EPC STORMWATER REVIEW COMMENTS
IN ORANGE BOXES WITH BLACK TEXT

UDON SOUTH SITE DEVELOPMENT PLAN 12265 HIGHWAY 94

COVER SHEET

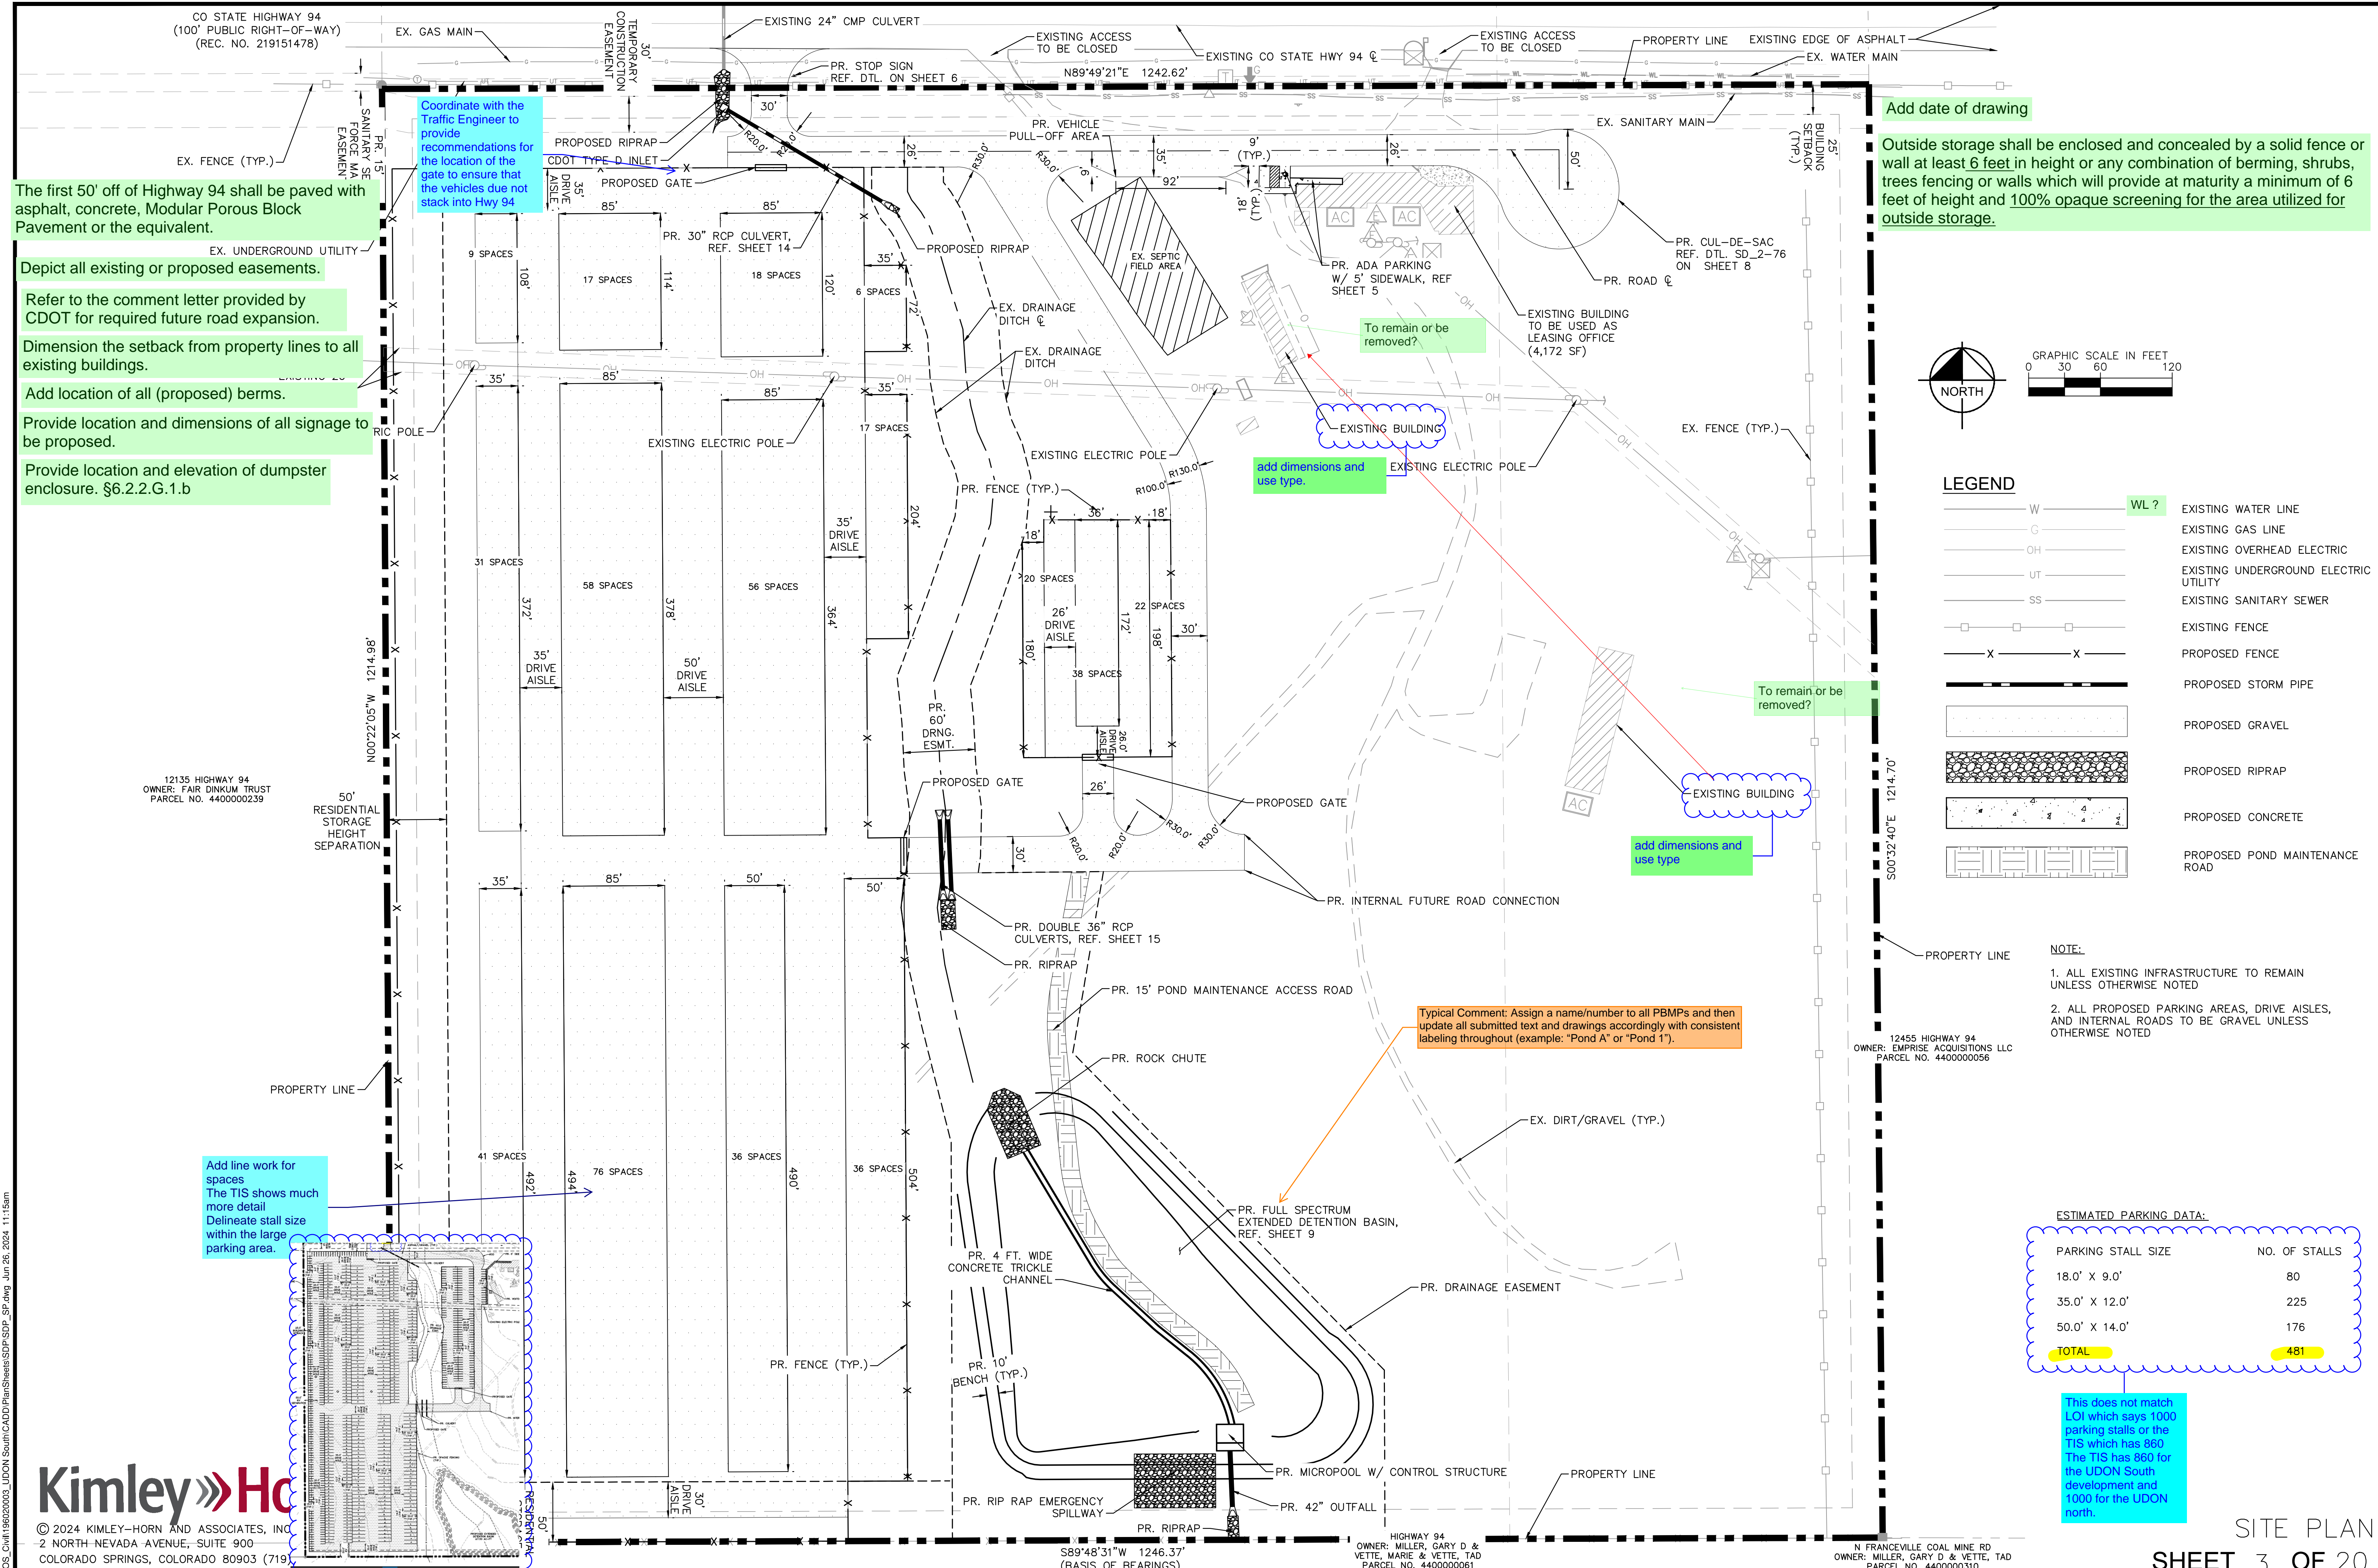
The first 50' off of Highway 94 shall be paved with asphalt, concrete, Modular Porous Block Pavement or the equivalent.

Depict all existing or proposed easements.

Refer to the comment letter provided by CDOT for required future road expansion.

Dimension the setback from property lines to all existing buildings.

Add location of all (proposed) berms.

Provide location and dimensions of all signage to be proposed.

Provide location and elevation of dumpster enclosure. §6.2.2.G.1.b

Coordinate with the Traffic Engineer to provide recommendations for the location of the gate to ensure that the vehicles do not stack into Hwy 94

Add date of drawing

Outside storage shall be enclosed and concealed by a solid fence or wall at least 6 feet in height or any combination of berming, shrubs, trees fencing or walls which will provide at maturity a minimum of 6 feet of height and 100% opaque screening for the area utilized for outside storage.

Typical Comment: Assign a name/number to all PBMPs and then update all submitted text and drawings accordingly with consistent labeling throughout (example: "Pond A" or "Pond 1").

Add line work for spaces
The TIS shows much more detail
Delineate stall size within the large parking area.

This does not match LOI which says 1000 parking stalls or the TIS which has 860. The TIS has 860 for the UDON South development and 1000 for the UDON north.

GRADING PLAN
 SHEET 4 OF 20

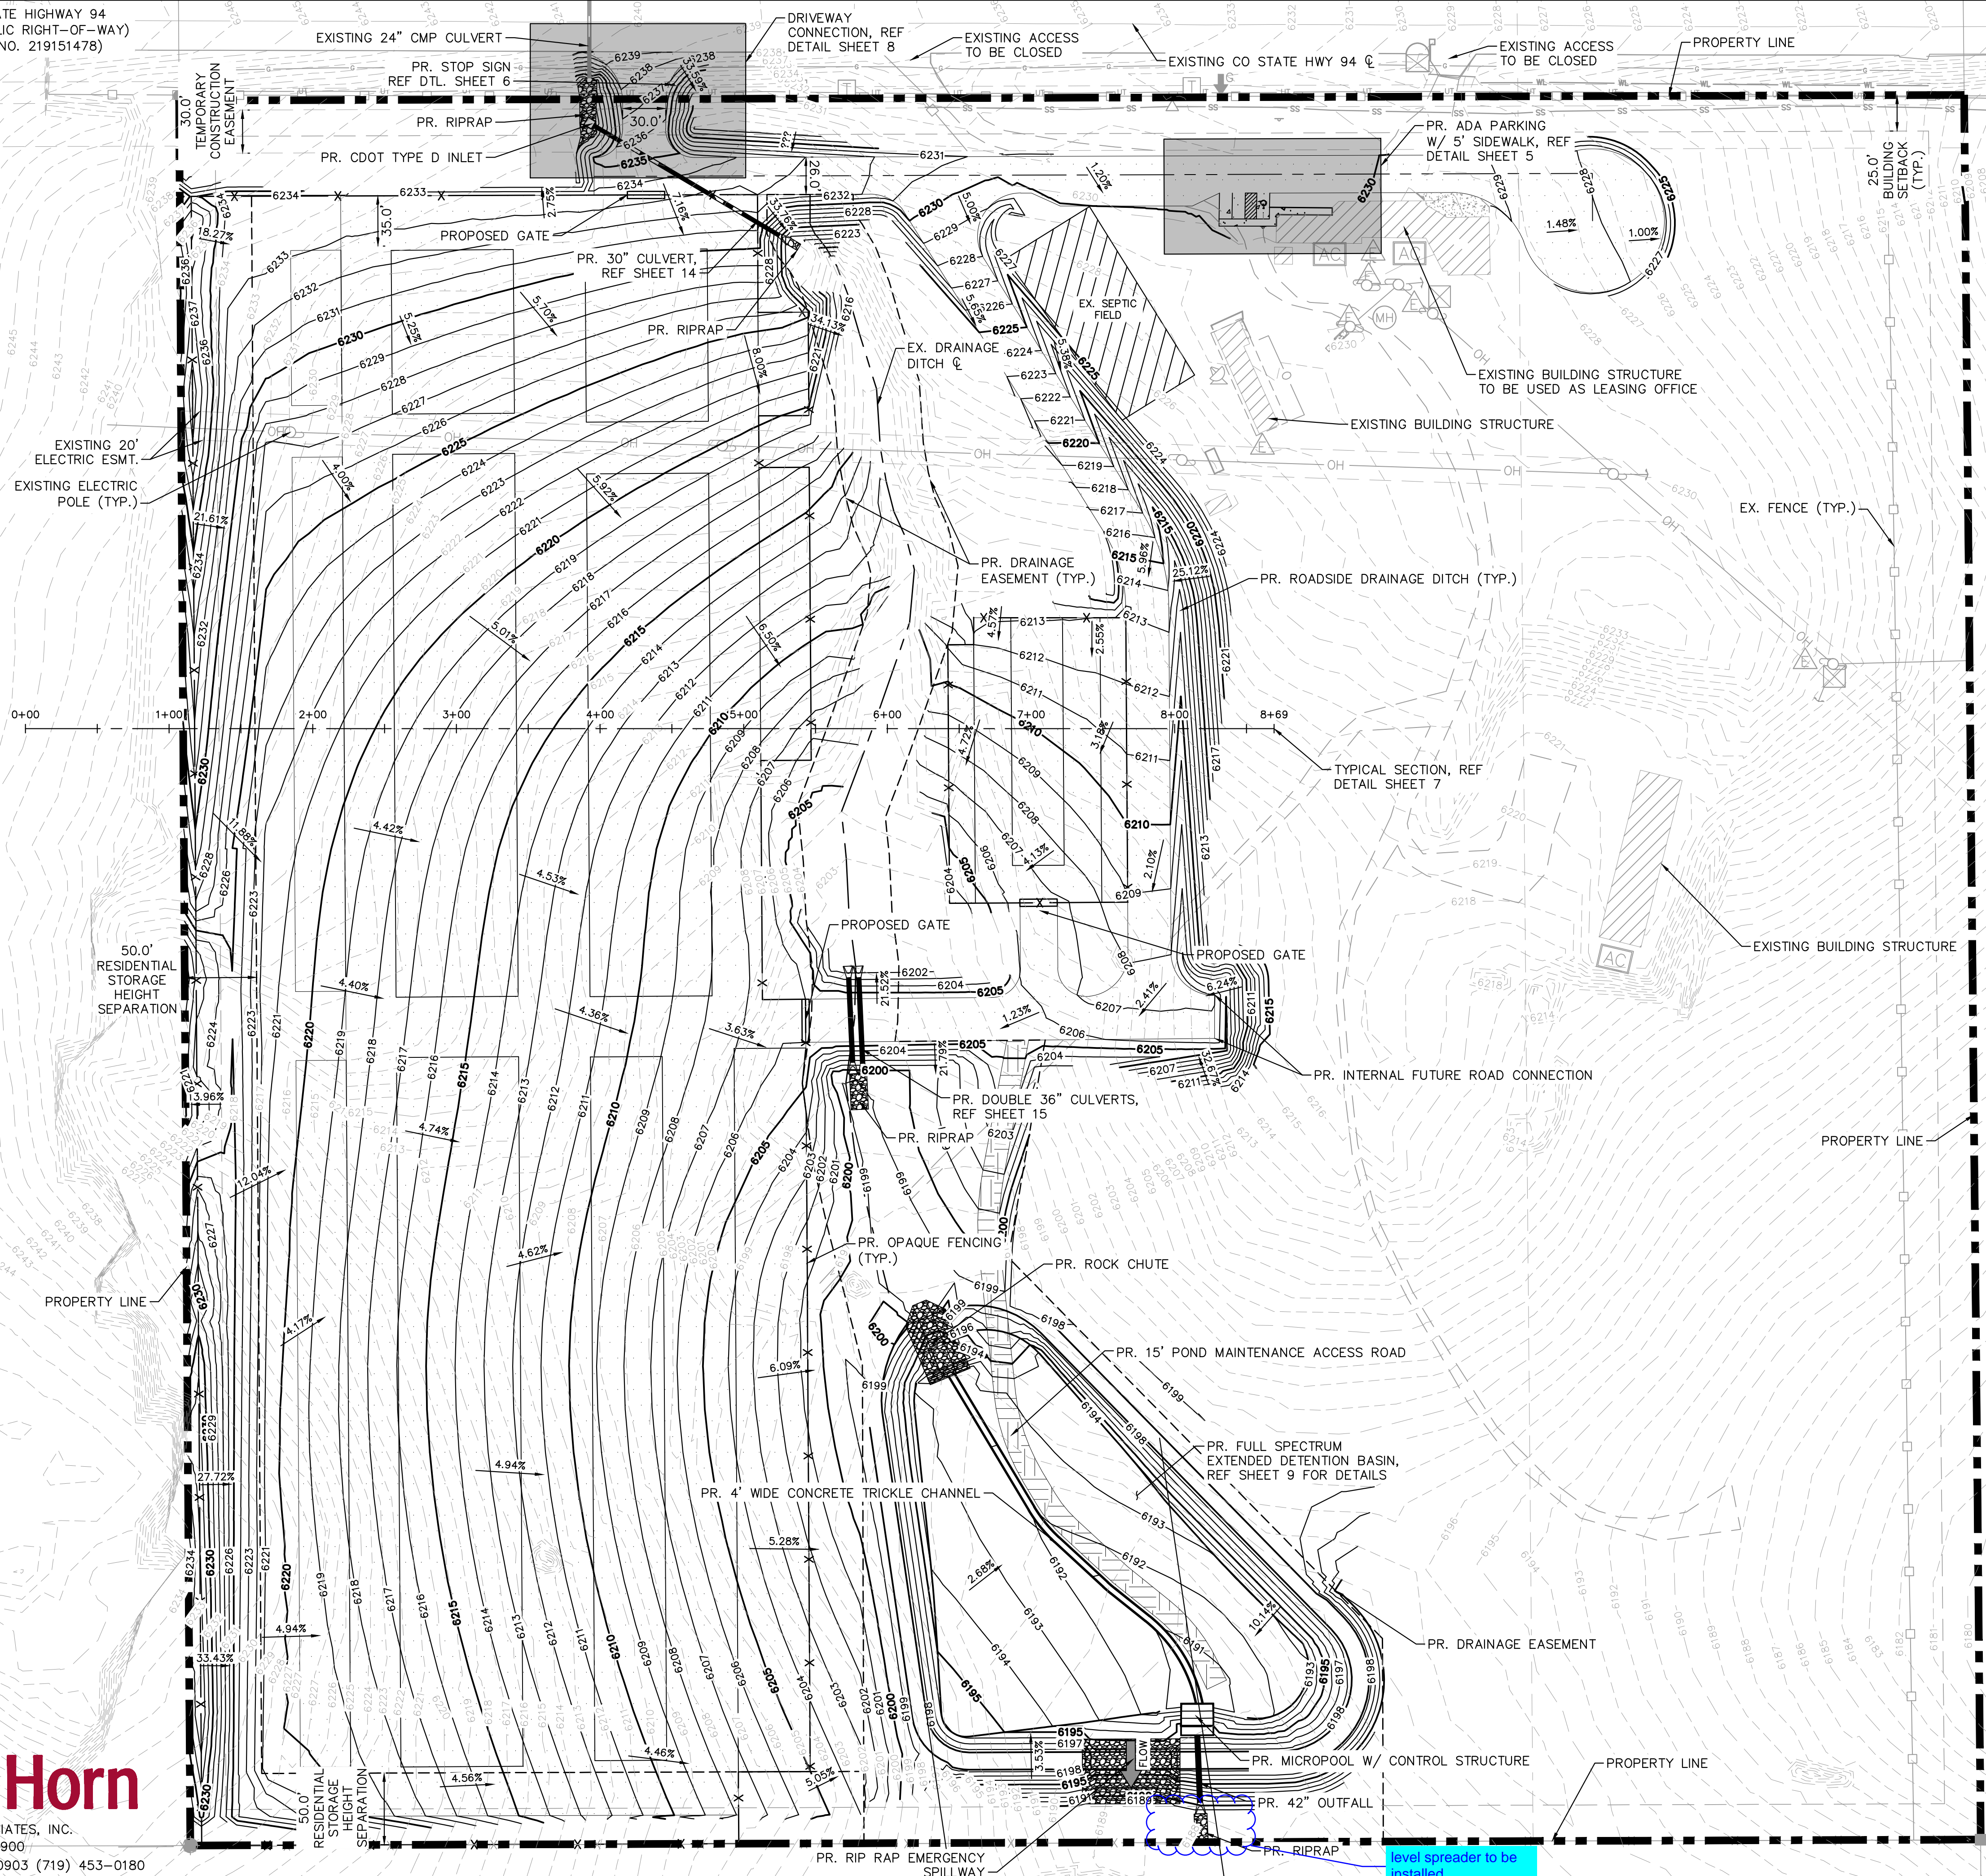
level spreader to be installed
